HOMOLOGATION AND TECHNICAL SPECIFICATION UPDATE BULLETIN

HOMOLOGATION	Rotax 125 Micro Max EVO	HOMOLOGATION NO.	110H
HOMOLOGATION	Rotax 125 Mini Max EVO	HOMOLOGATION NO.	111H
HOMOLOGATION	Rotax 125 Junior Max EVO	HOMOLOGATION NO.	112H
HOMOLOGATION	Rotax 125 Max (Senior) EVO	HOMOLOGATION NO.	113H
BULLETIN NO.	Rotax 3 (EVO)	BULLETIN DATE	23 March 2016

Figure 1.1: Original Support Plate (Part No. 651 053) to suit 125 MAX EVO Engines.

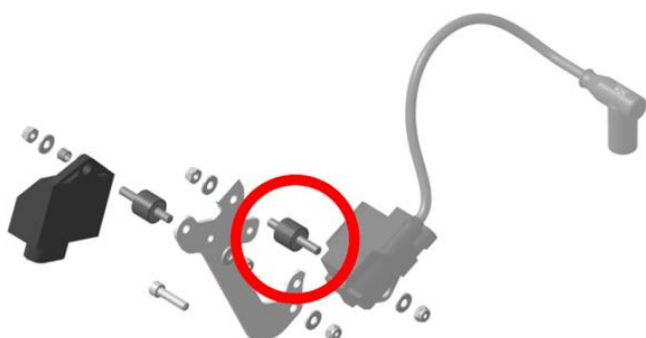
To minimize the vibration level of the electrical components BRP-Rotax have created a new Support Plate (Part No. 481 257) which carries the ECU, ignition coil and magnet valve in combination with the improved cable harness. Both the original support plate (Part No. 651 053) and the new support plate are legal.
